Product Change Notice

Issue Date: 20-January-2022

New dice replacement for PCB base Seven Segment Display and Custom Module

Effect of Change on Fit, Form, Function, Quality, or Reliability:

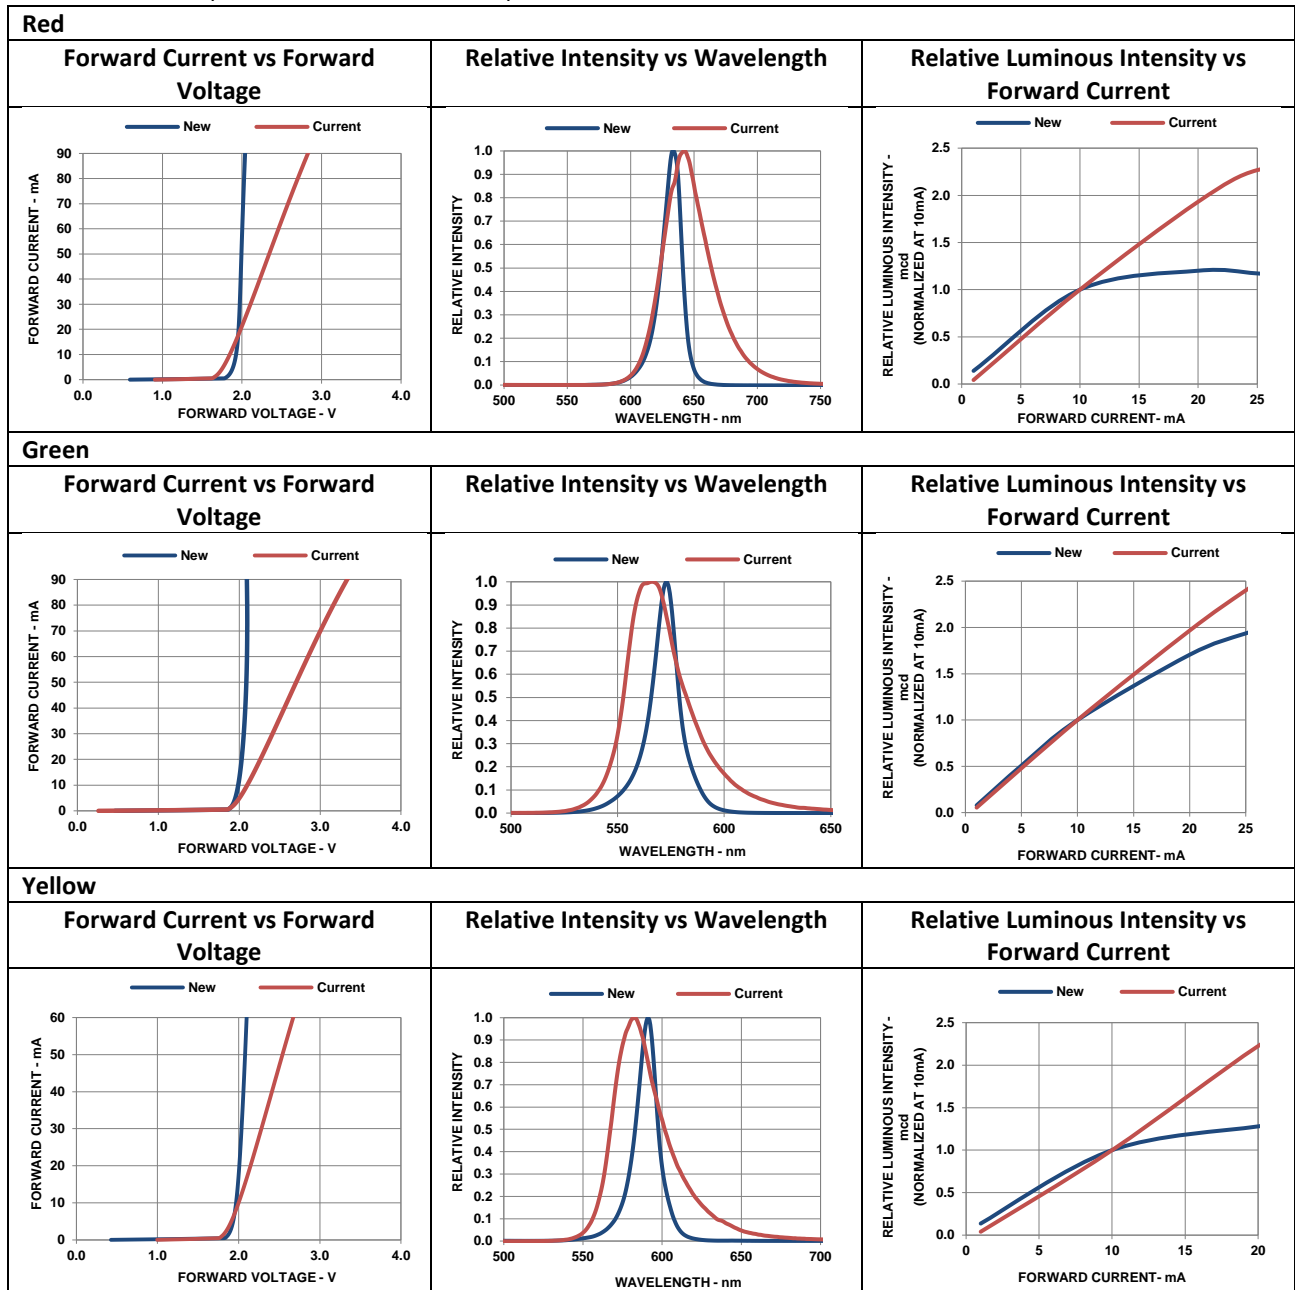
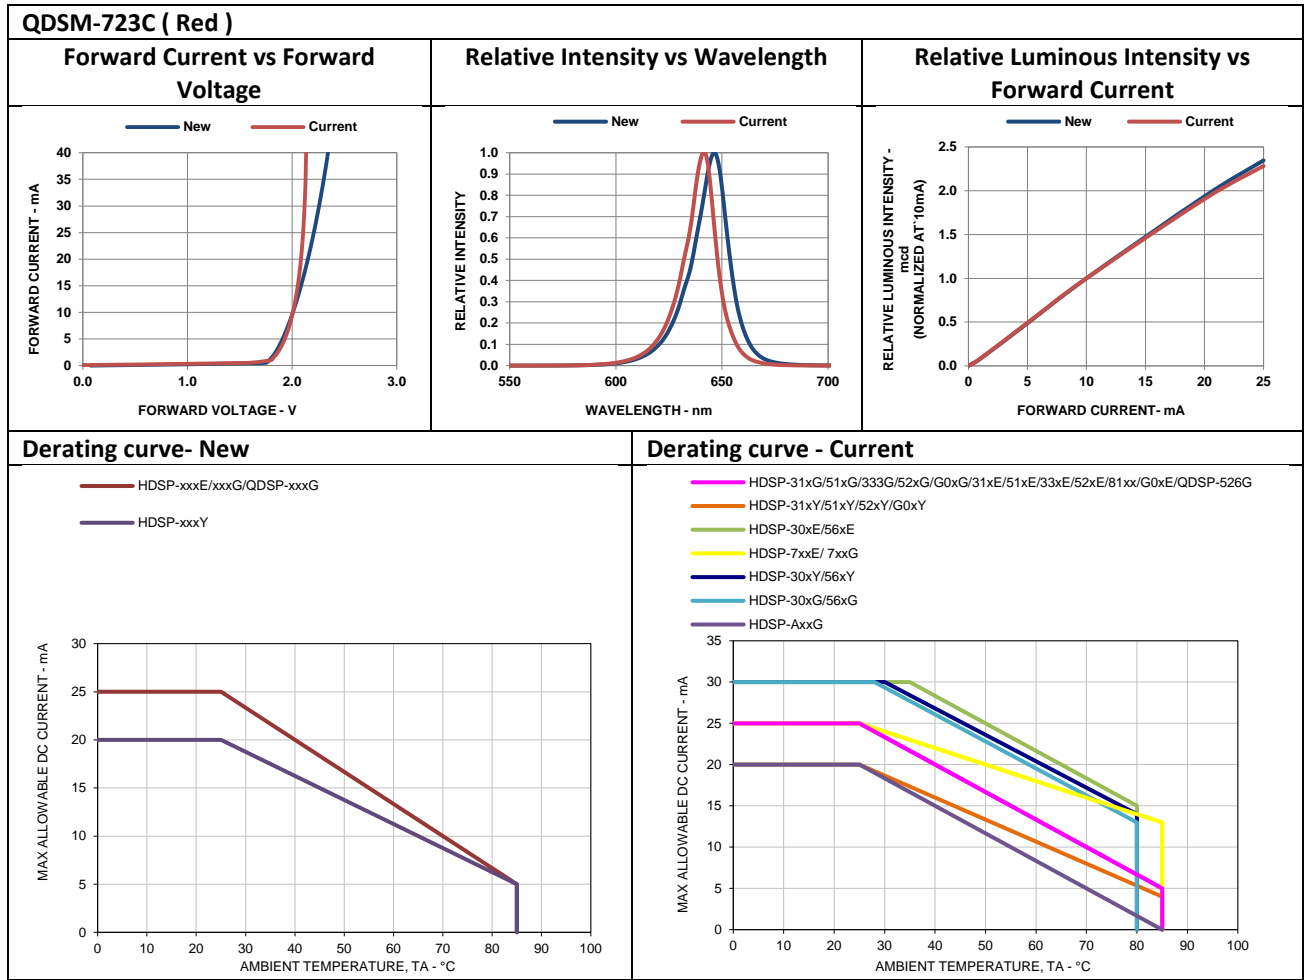
The new dice (AllnGaP) shall be replacing current dice for part numbers above.

Following are changes in product characteristic:

1. Forward Voltage vs Forward Current
2. Relative Intensity vs Wavelength
3. Relative Intensity vs Forward Current
4. Storage temperature & operating temperature range will be standardized to -40°C/85°C
5. Power dissipation
6. Peak forward current
7. DC forward current
